LAND USE APPLICATION SET - NOT FOR CONSTRUCTION

PACT CHARTER SCHOOL
RAMSEY, MN

LANDSCAPE DETAILS

SHEET
C702
THE SHEET SCALE
0' 1/2" 1"

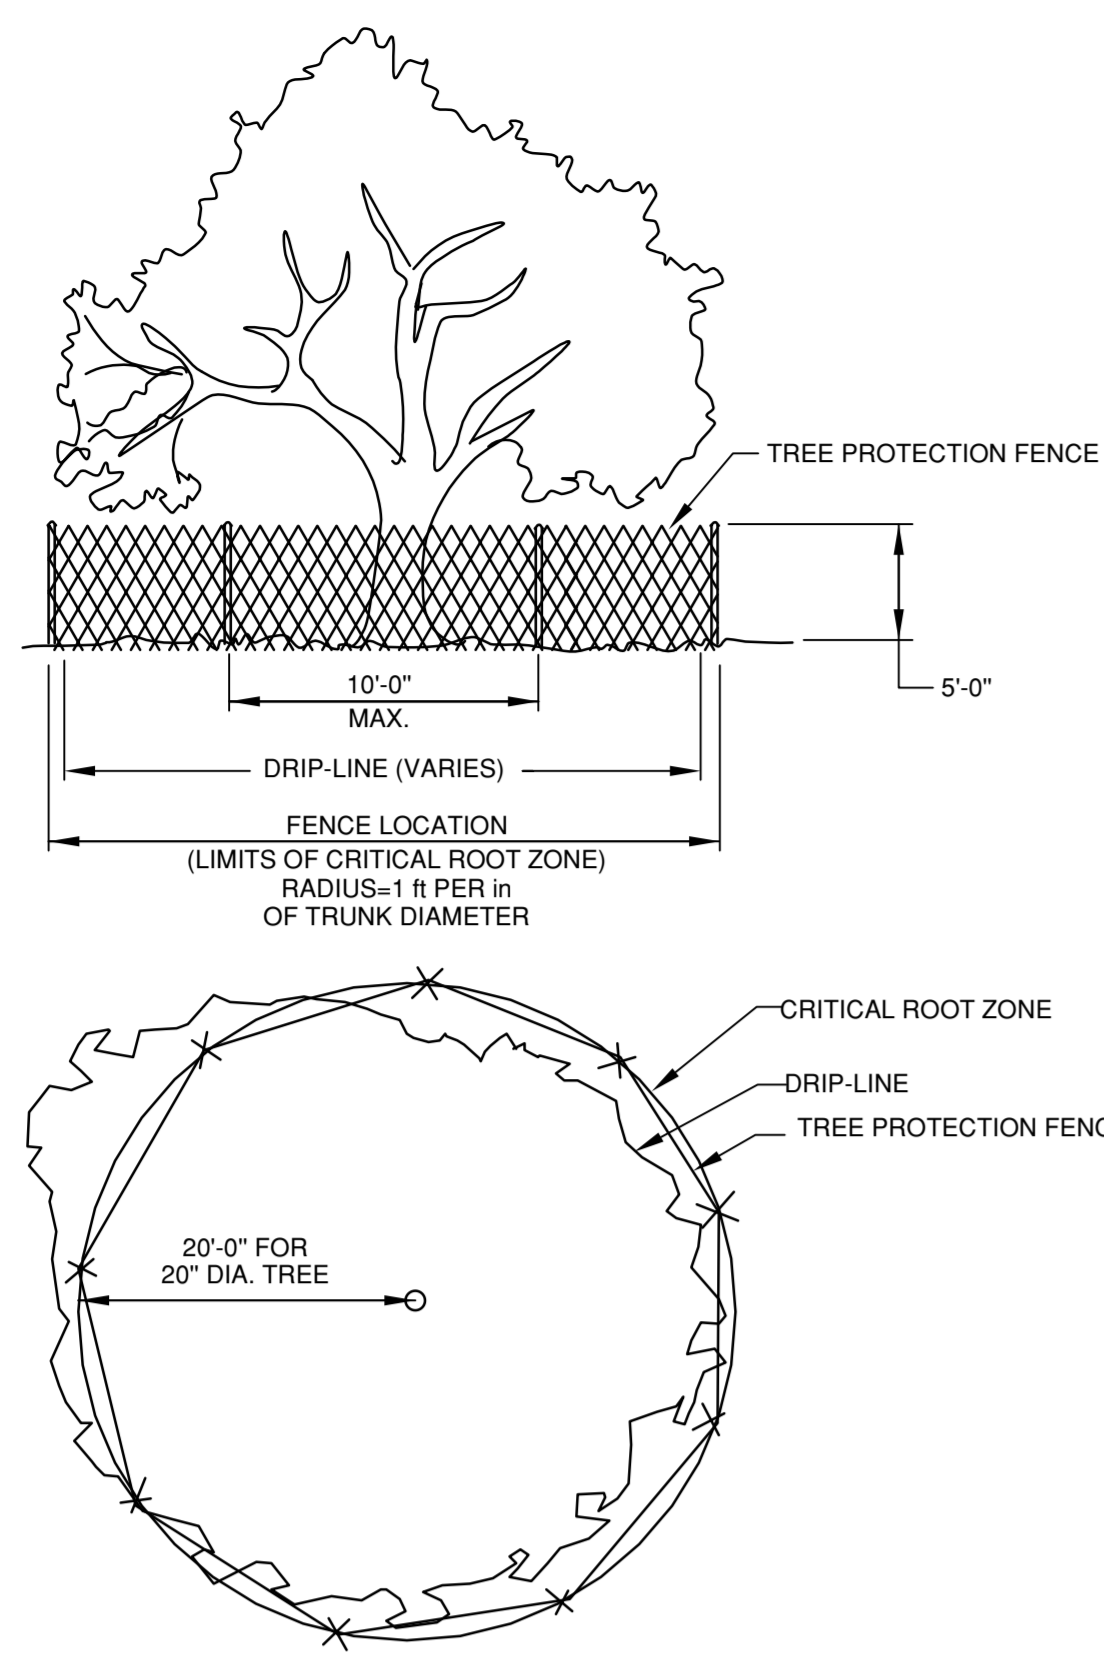
1 - Break Between Seeding Types

There's no apparent break between Seed 2 and Seed 3, they sort of merge together here. Use a different symbol/shading/hashmark for each seed type.

2 - Seed Type?

Are these different seed types? If so, what are they?

3 - Changemark note #01

Add several shrubs to the basin slopes to aid with bank stabilization.

4 - Changemark note #02

As noted in the grading plan, terrace this slope more and then add trees at the different levels. Otherwise, this area will just be a 10' drop and not look intentional.

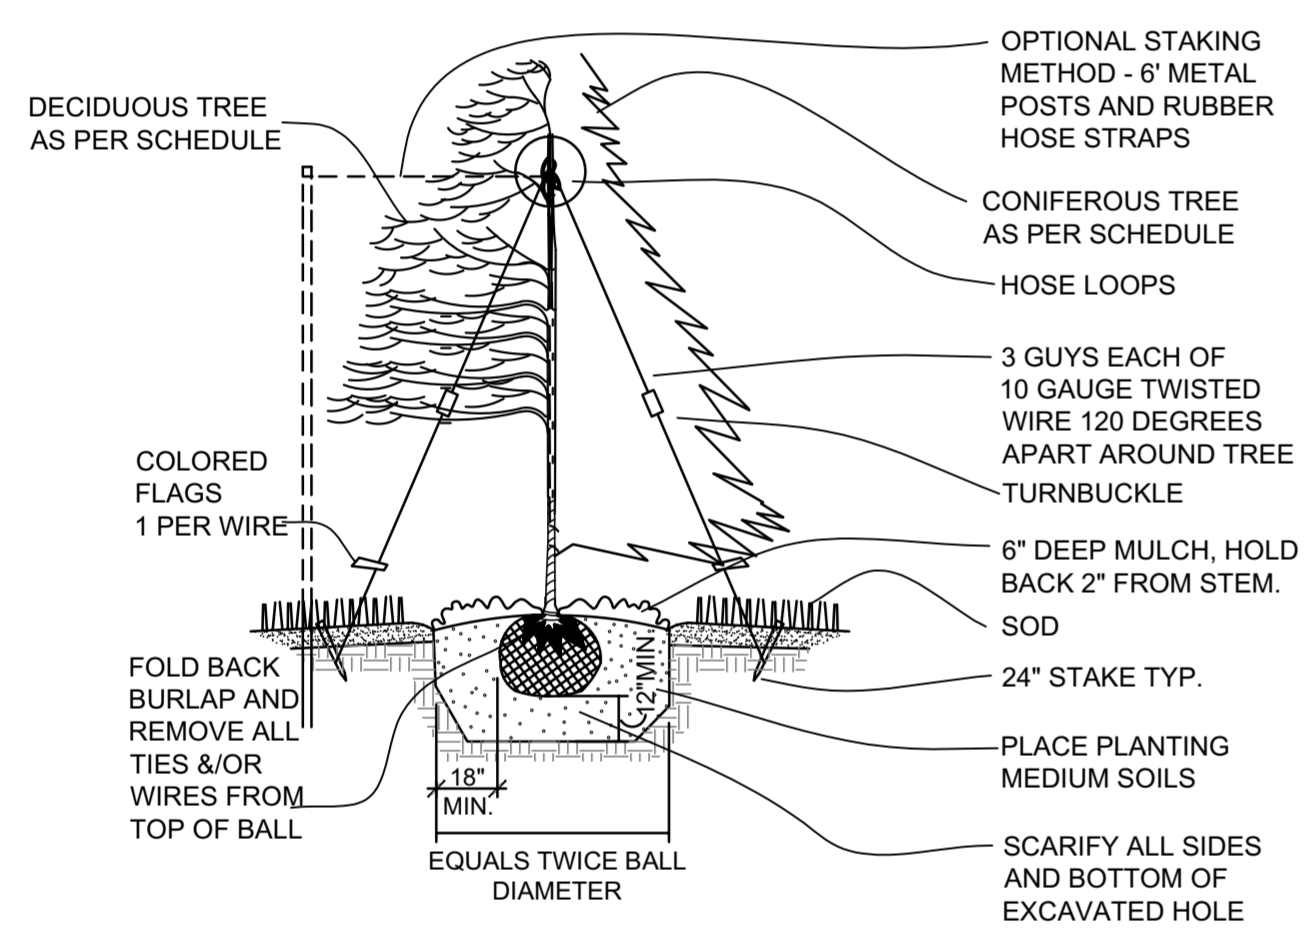
5 - Changemark note #03

Consider a row of evergreens and overstory trees to act as a windbreak for the comfort of the athletes.

2
C702
TREE PLANTING DETAIL
NOT TO SCALE

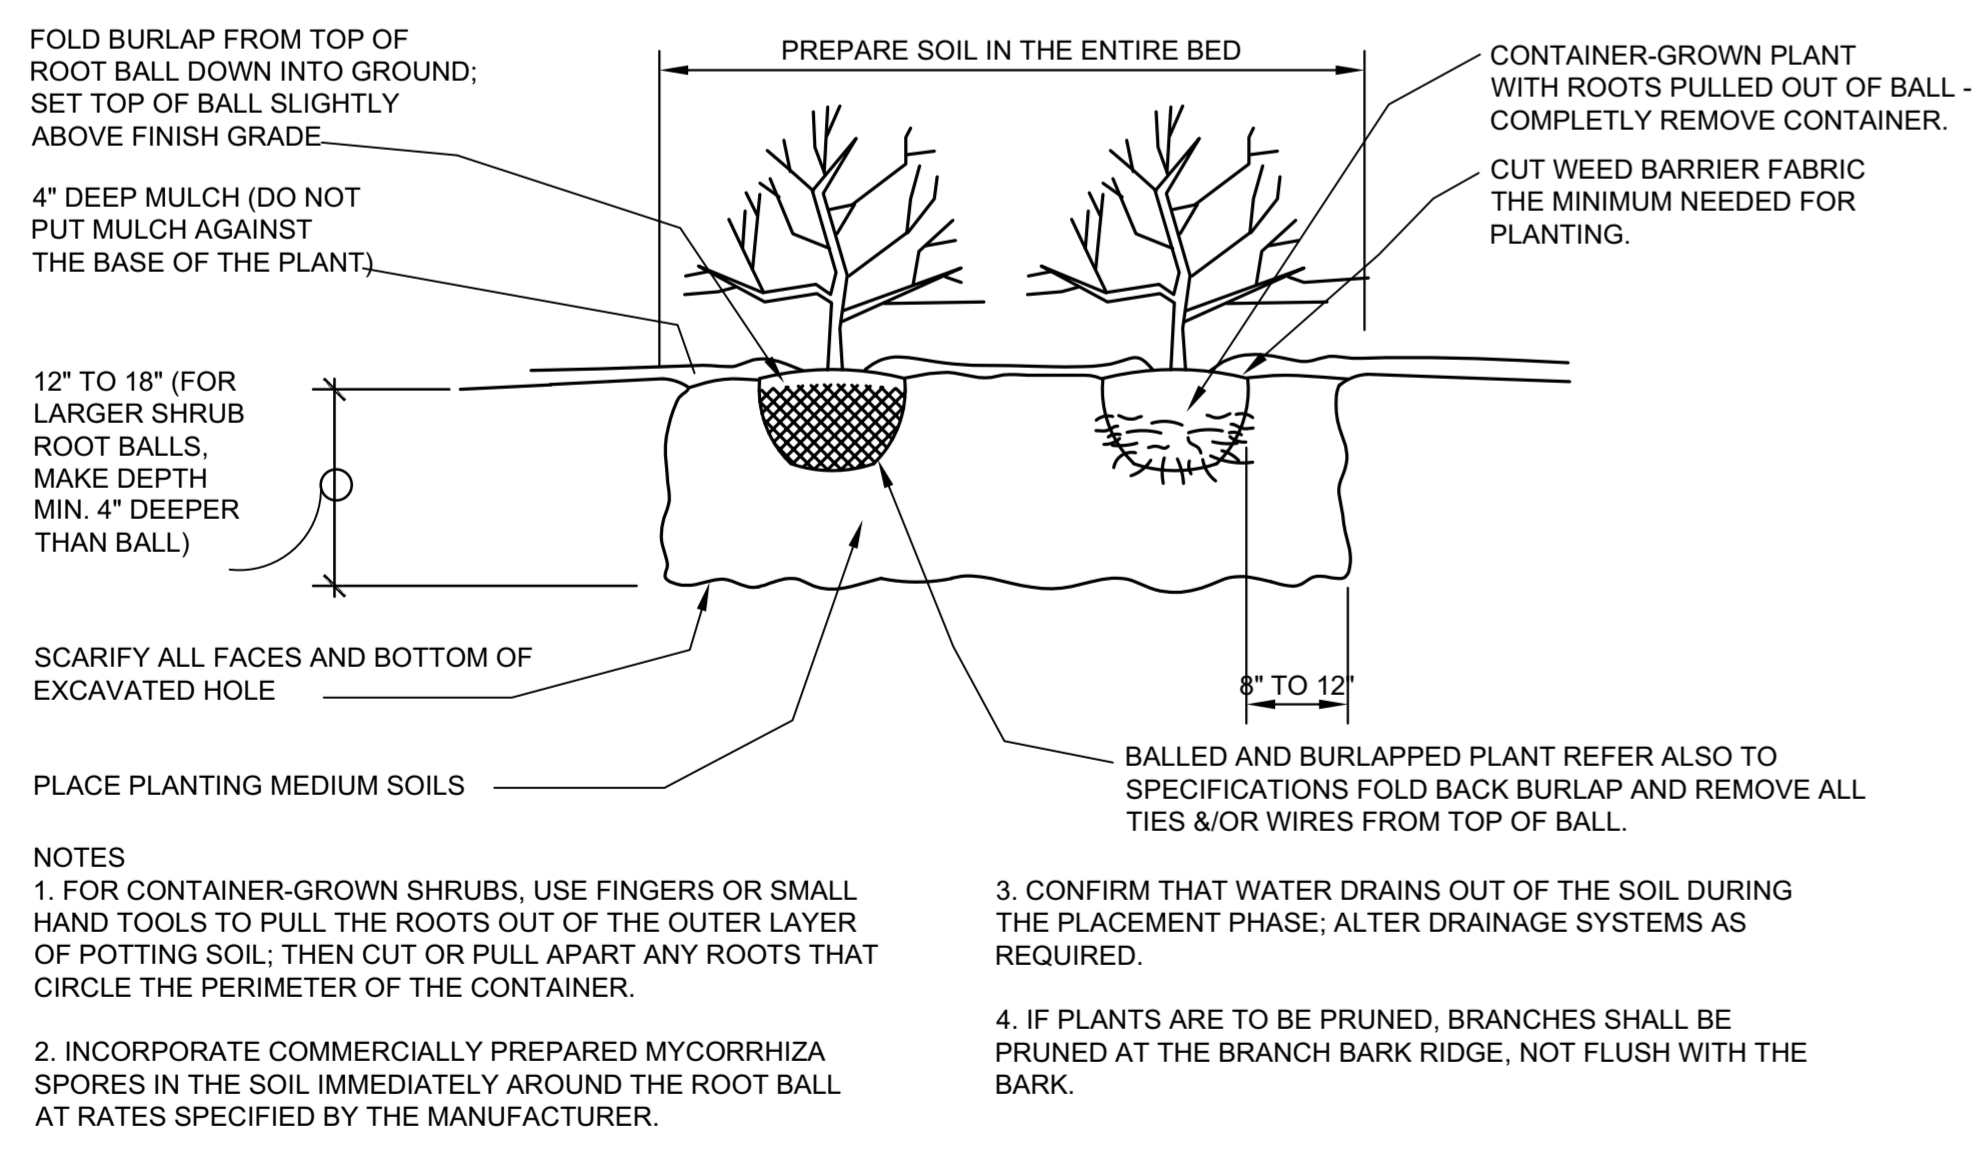
1 - Planting Depth

Created by: Chris Anderson
On: 05/12/2022 08:51 AM

Tree shall be planted so that the first set of primary roots is at finished grade. This may require opening top of burlap to find primary roots before setting tree in planting hole.
